ADDENDUM

Project: **Crestwood School District
Cherry Hill Baptist Church
Administration Relocation and Addition**

Date: **August 15, 2023**

Addendum Number: **#002**

TYPICAL STEEL DETAILS

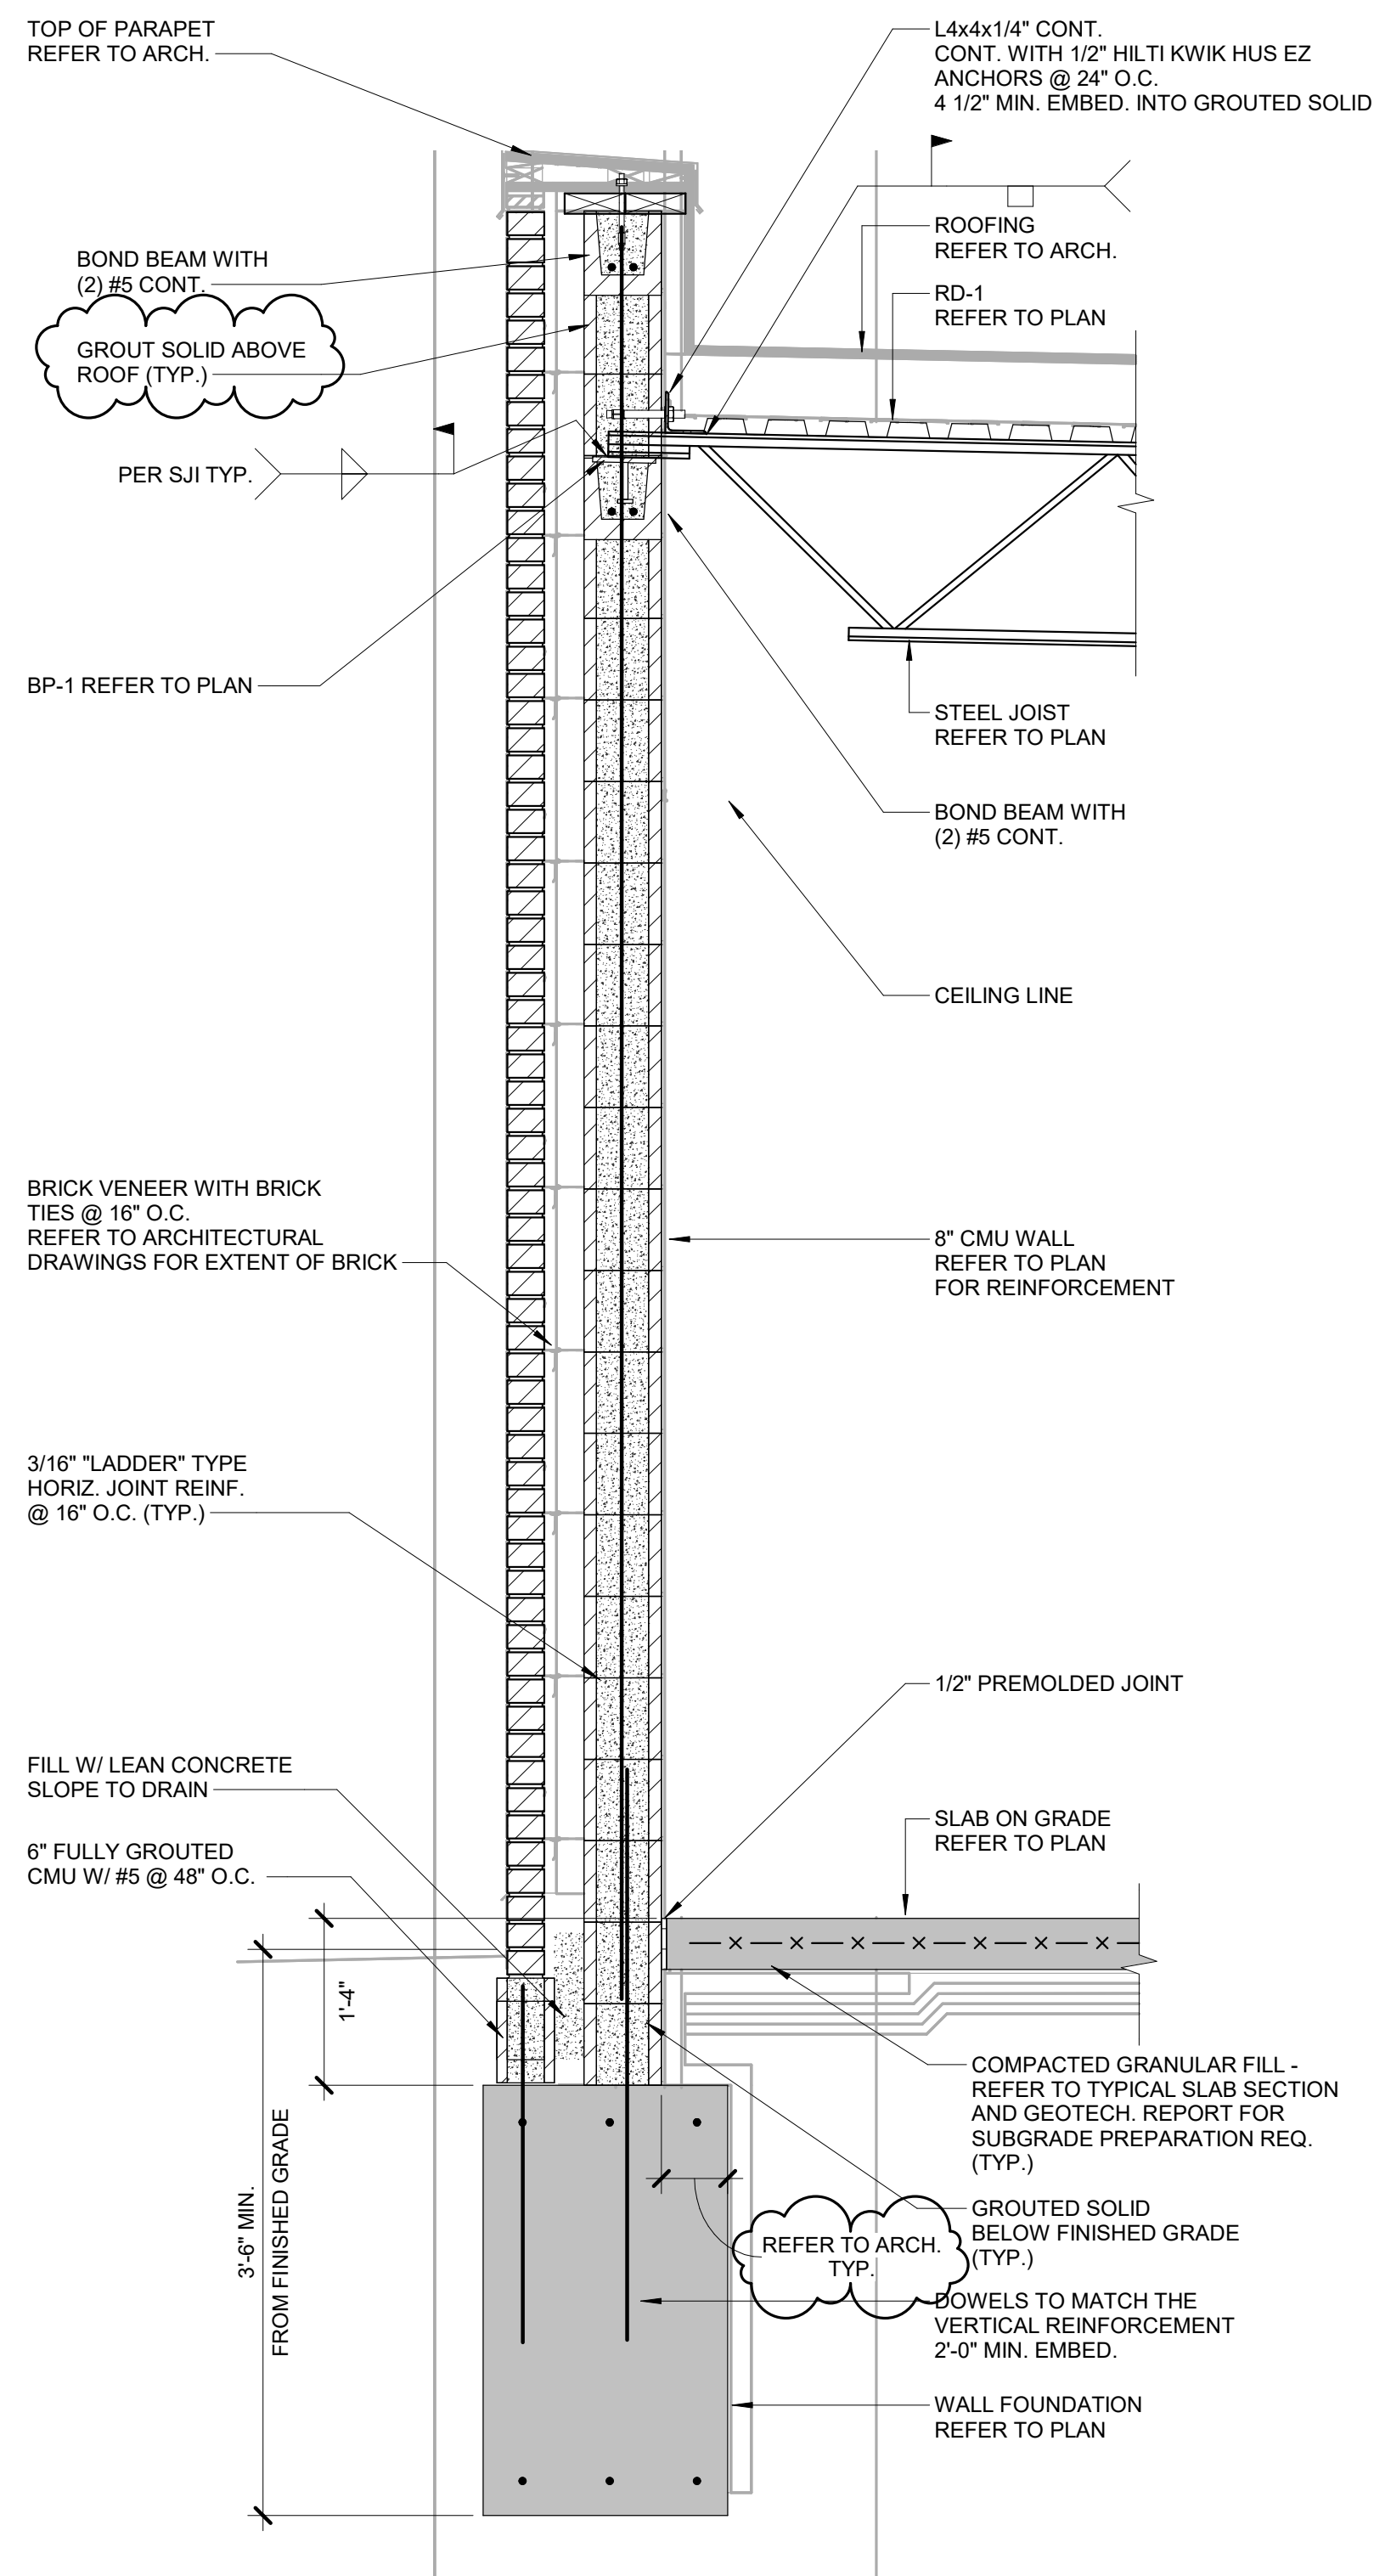
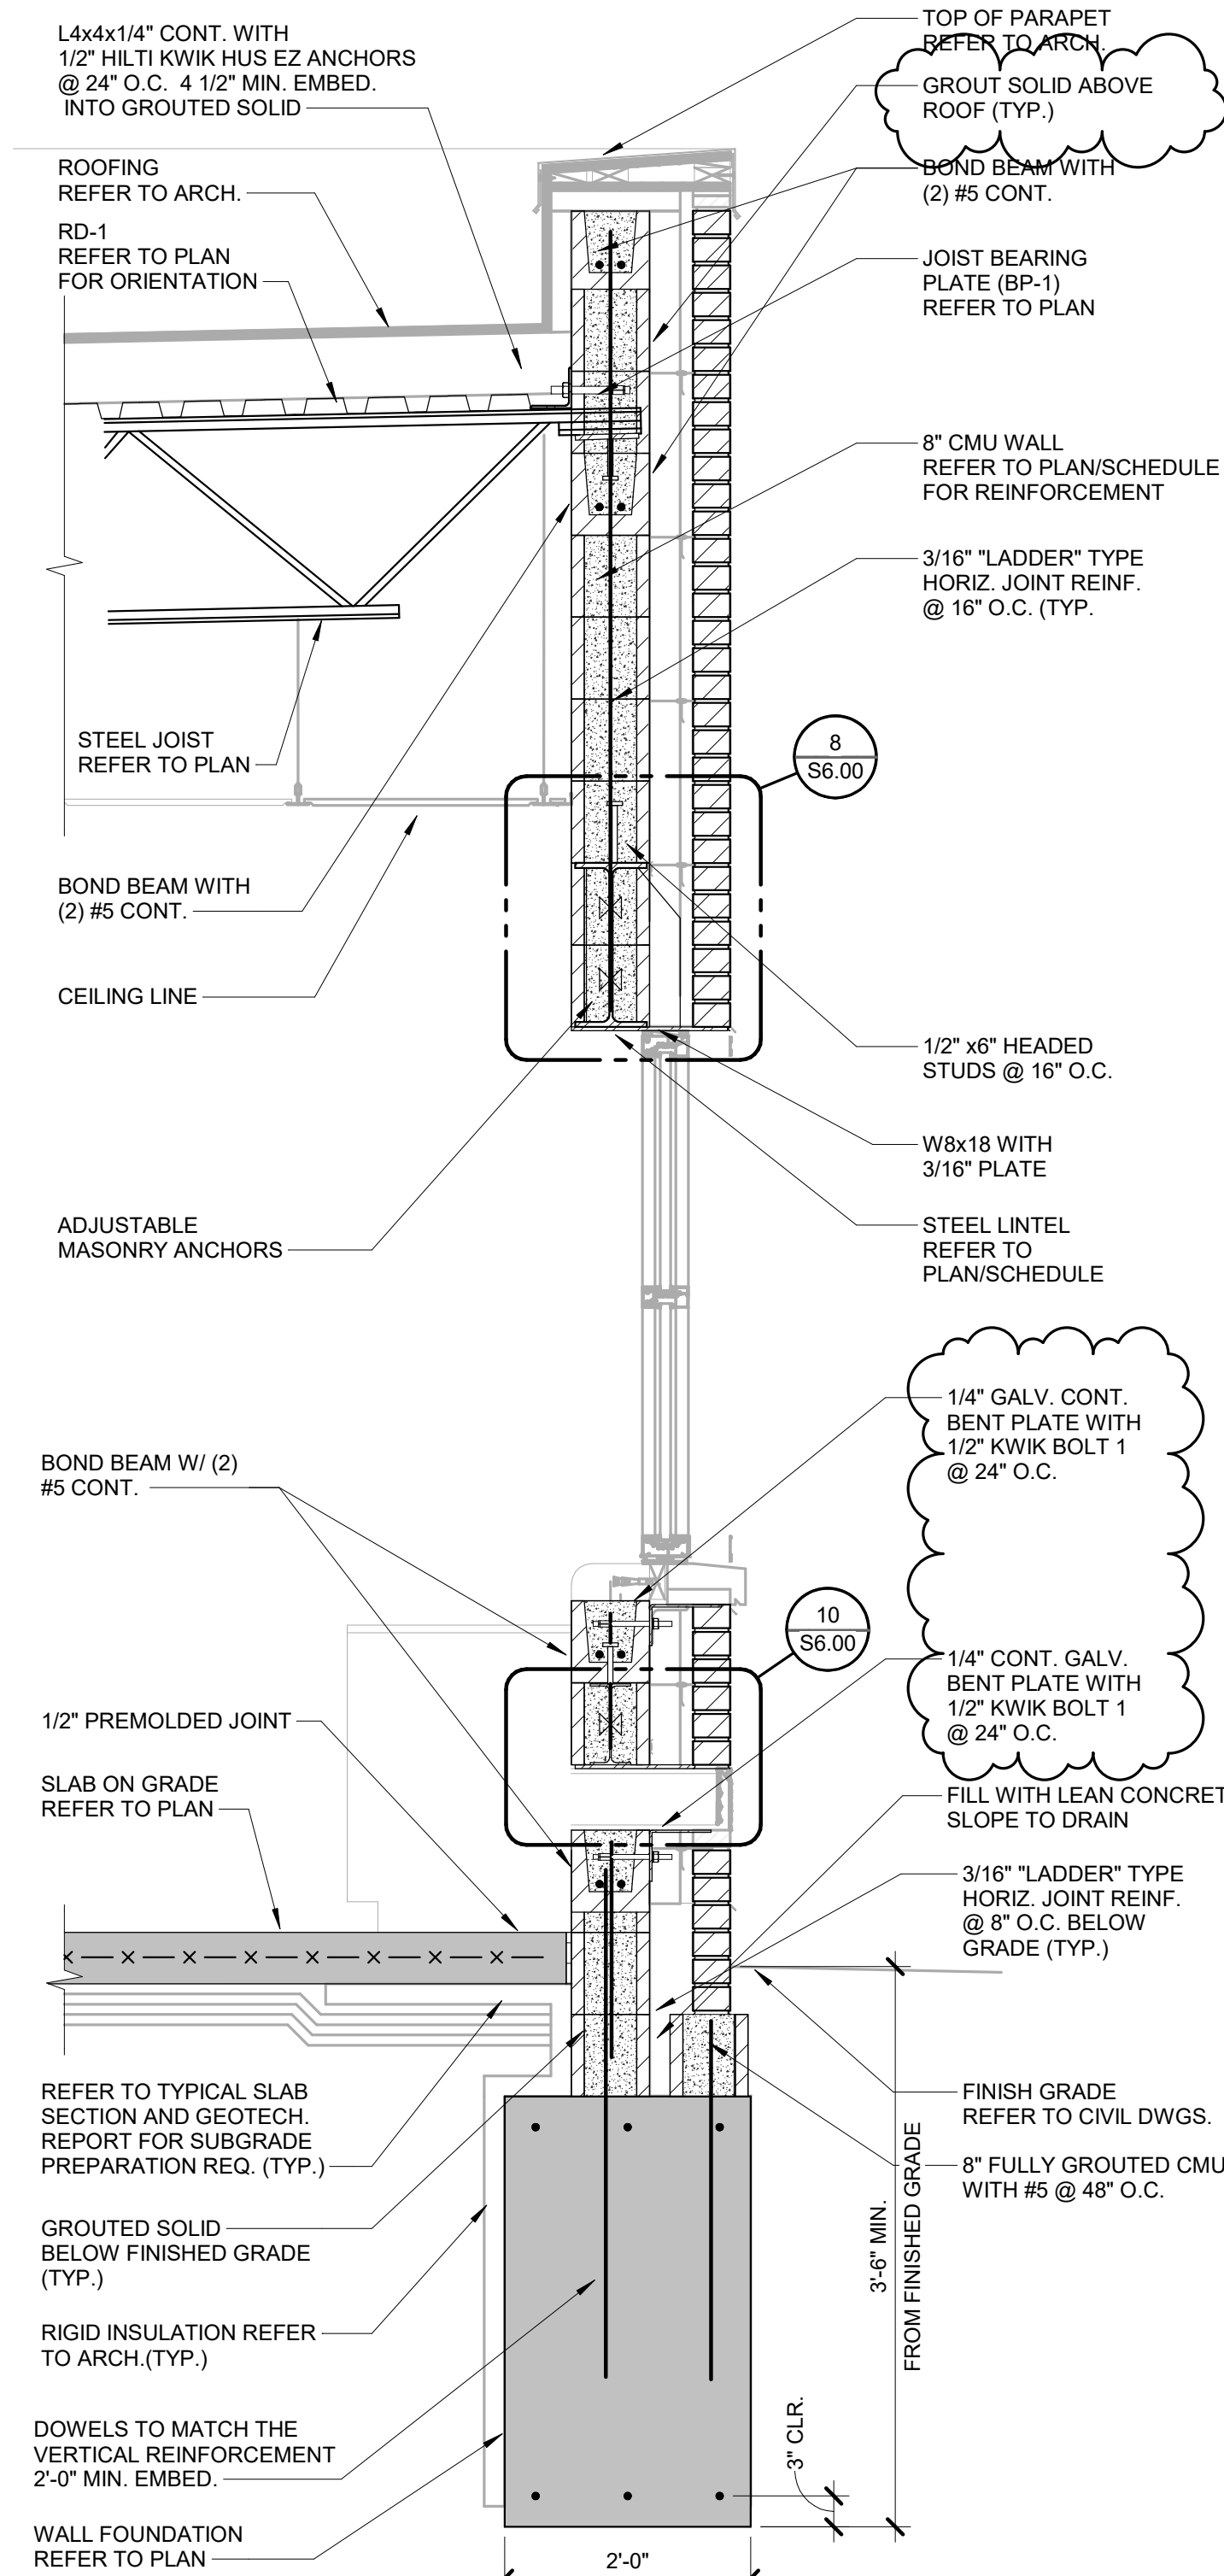
S6.01 - Typical Sheet Details

ADD: Sheet to drawing set.
